Application Number: 09/815,567
Filing Date: March 23, 2001
Appellant(s): PARKER, FRED T.

EXAMINER'S ANSWER

This is in response to the appeal brief filed July 8, 2008 appealing from the Office action mailed on February 1, 2008.

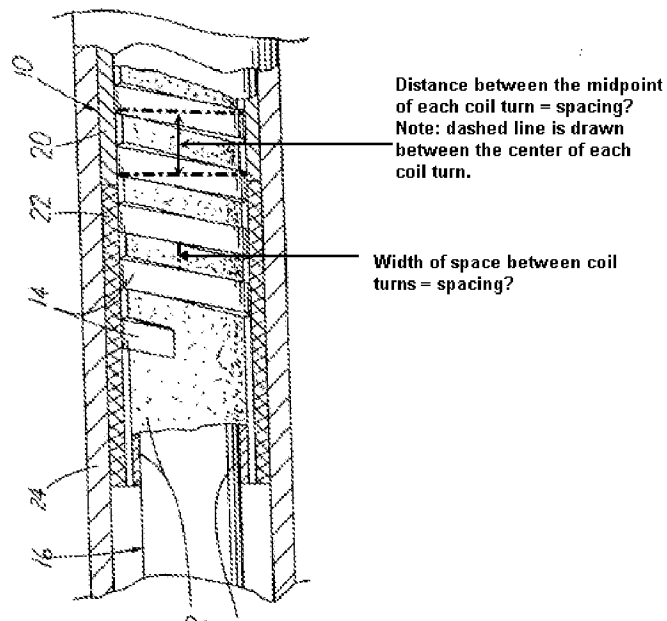
Regarding the rejections of claims 1-13, 15-20 and 22 under 35 USC 112 second paragraph, the Examiner maintains that it isn't clear how the spacing between the coil turns is measured. For e.g., is the "spacing" the width of the space between the coils or the distance between the midpoints of the coils as illustrated on the following page.
